**SELECTIVE  
MODIFICATIONS  
TO**

150 WORTH AVE  
PALM BEACH UNIT 136  
FLORIDA 33480

### RFI 136

**4 COLUMN PLATE DETAIL TOP AND BOTTOM**  
Scale: 3" = 1'-0"

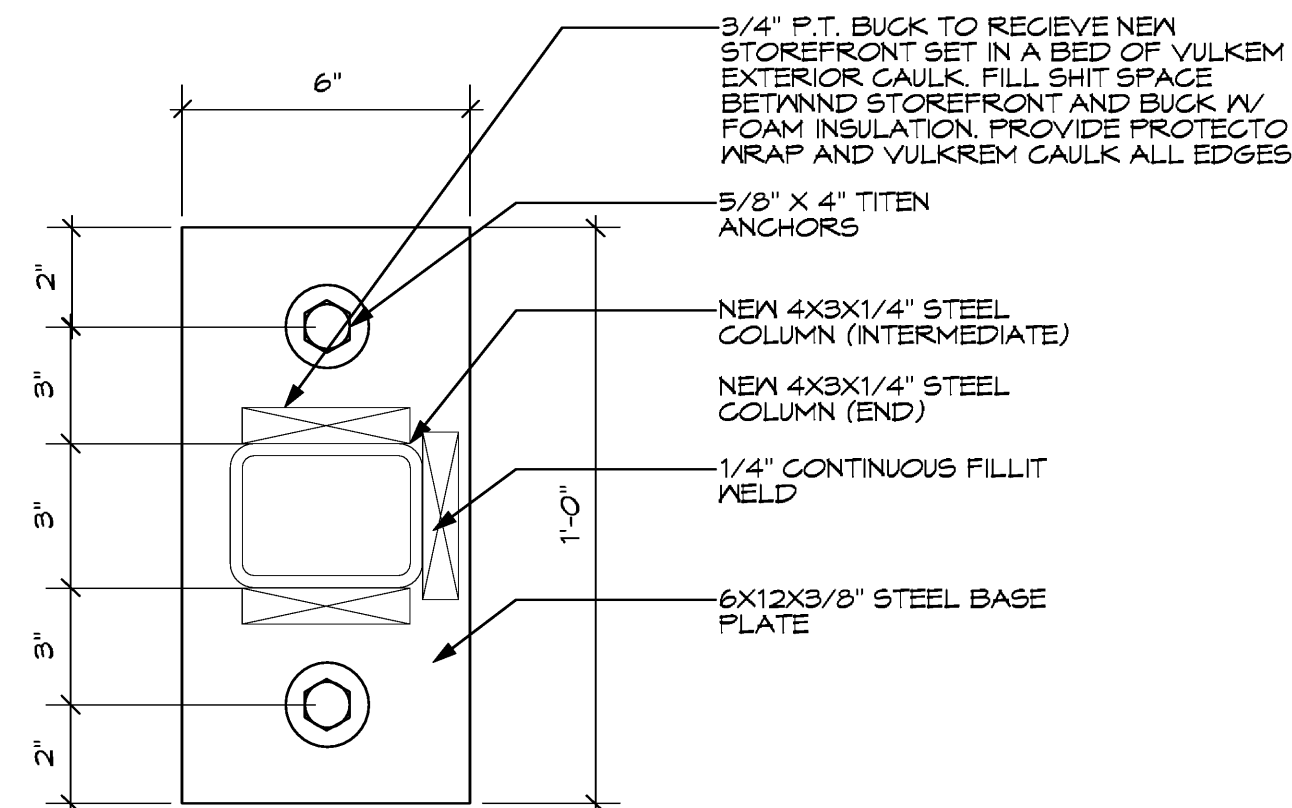
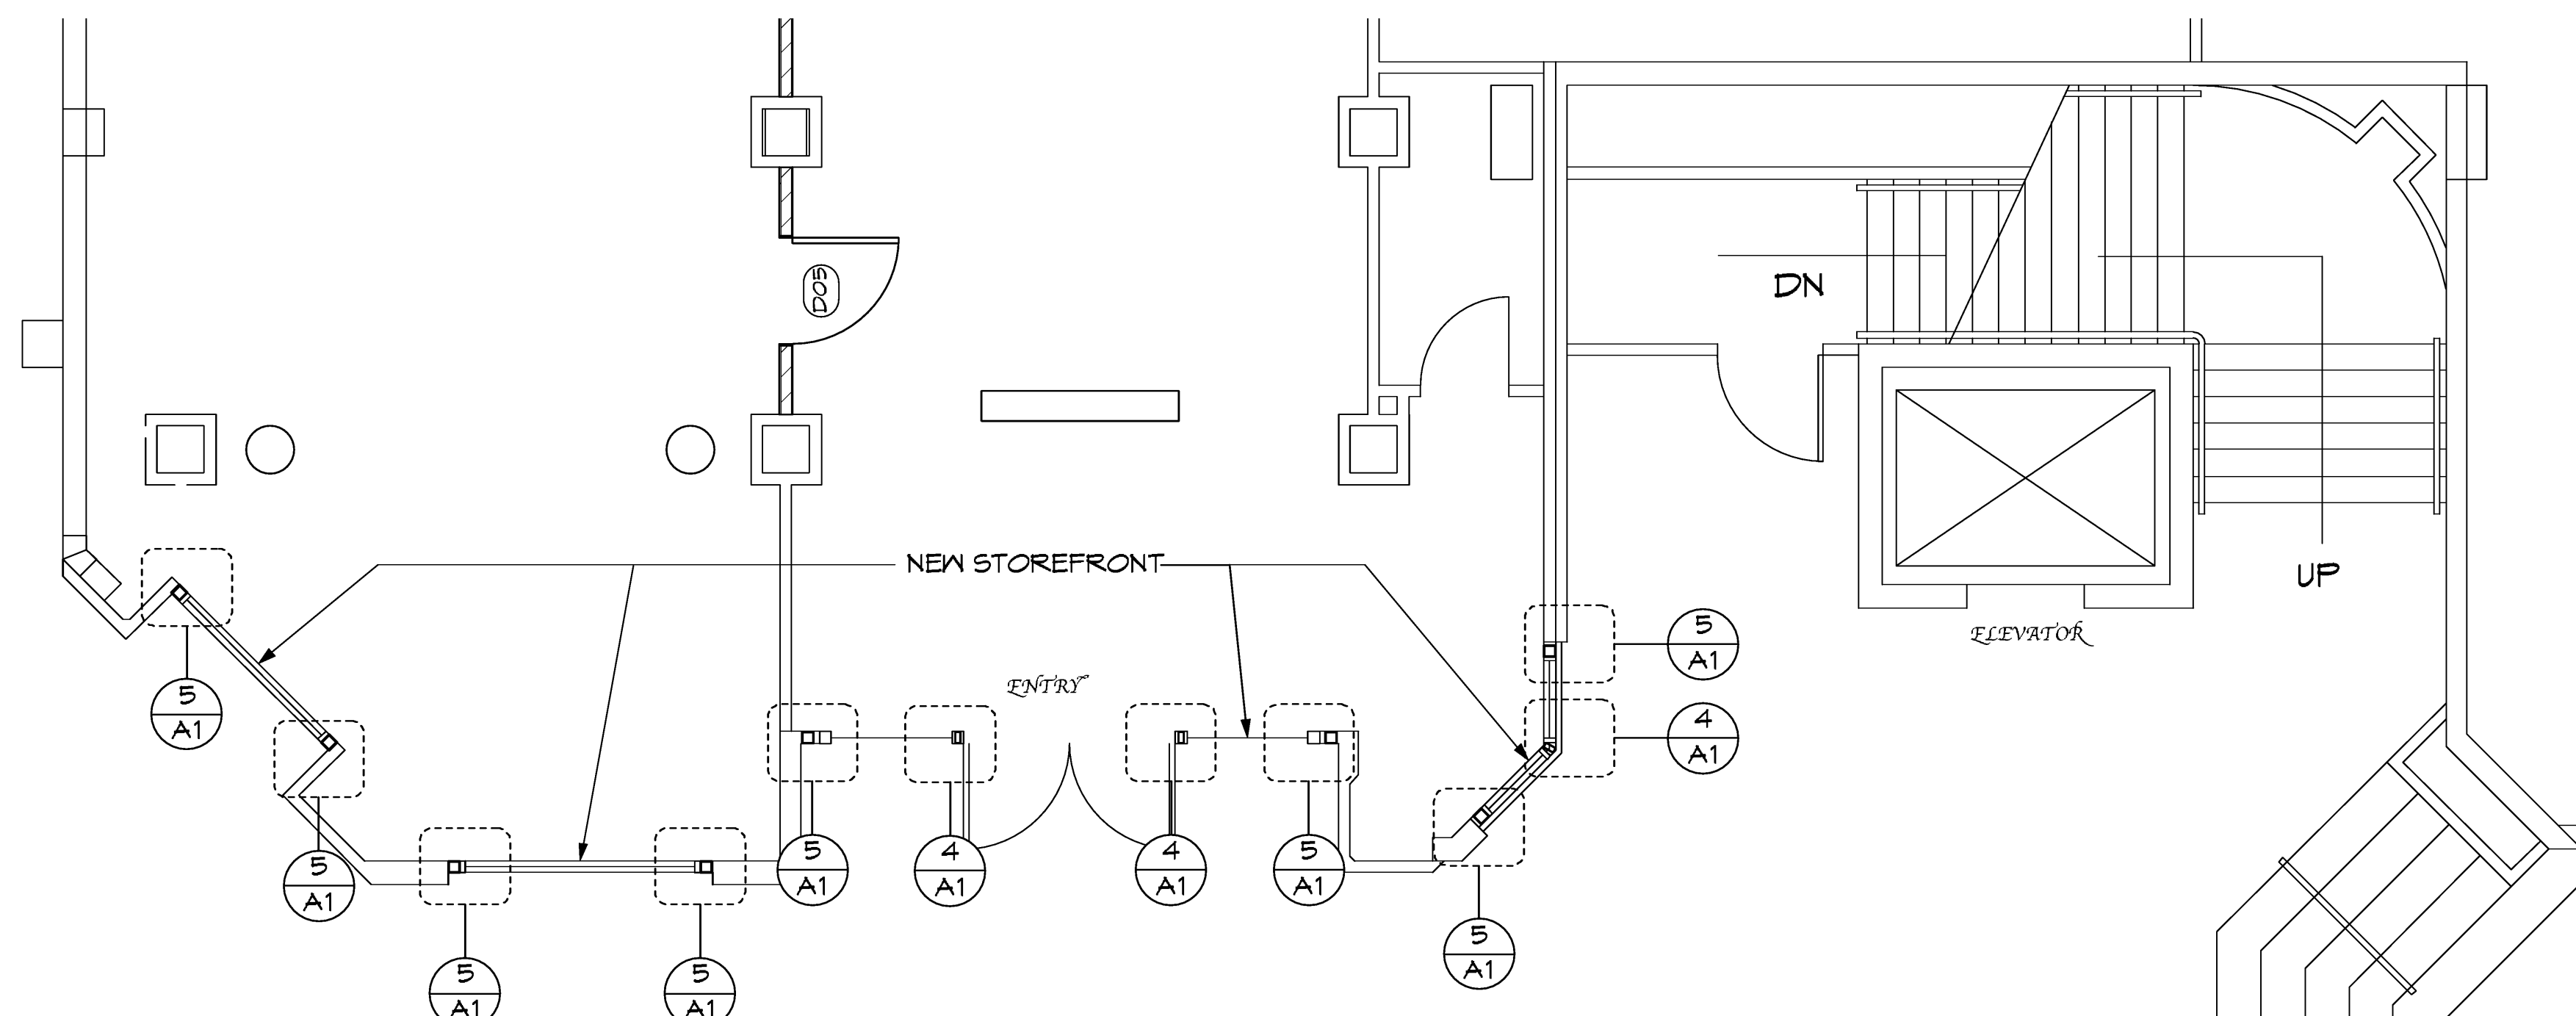
11. The walls shown with the pocket doors are shown as new but are not shown as being demo'ed. Are **these** new walls? **SEE REVISED PLAN**
12. The note 4-S1 should be corrected before permitting. **NOTED**

**3 SECTION THRU STOREFRONT**  
Scale: 1/2" = 1'-0"

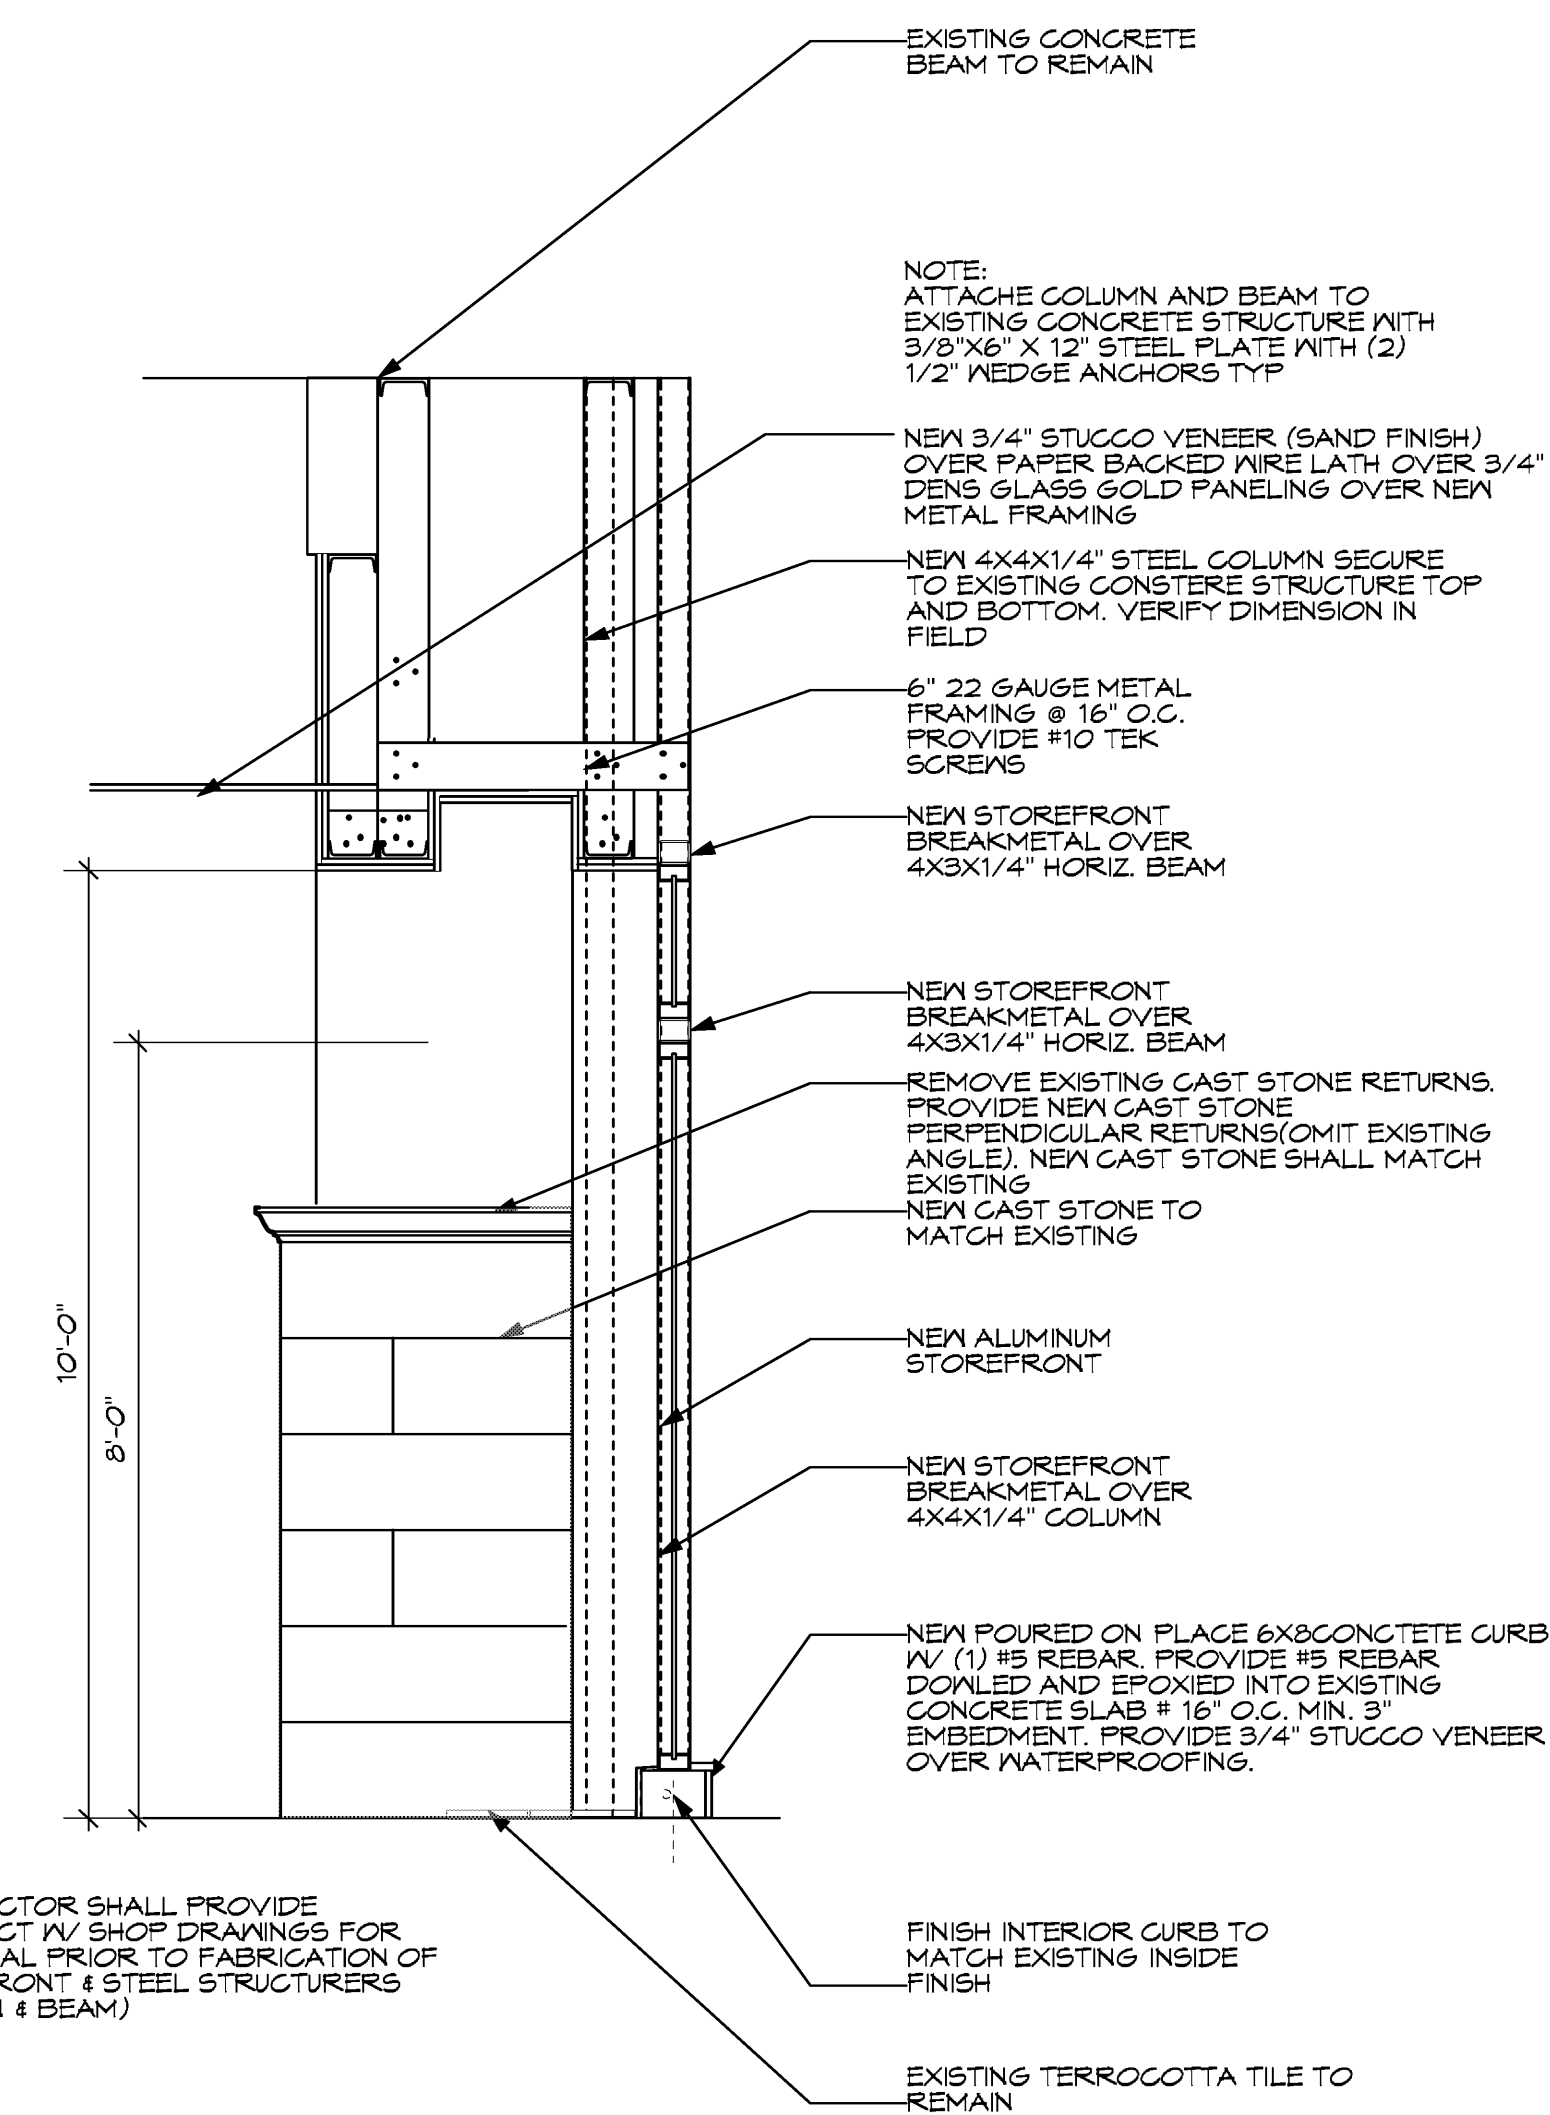
13. Note 3-S1 indicates an additional 4x4x1/2 steel column not shown elsewhere on the plan. Please clarify this detail. **PLEASE CLARIFY QUESTION**
14. There are no light fixture models/catalog numbers listed. **SEE ELECTRICAL PLAN**
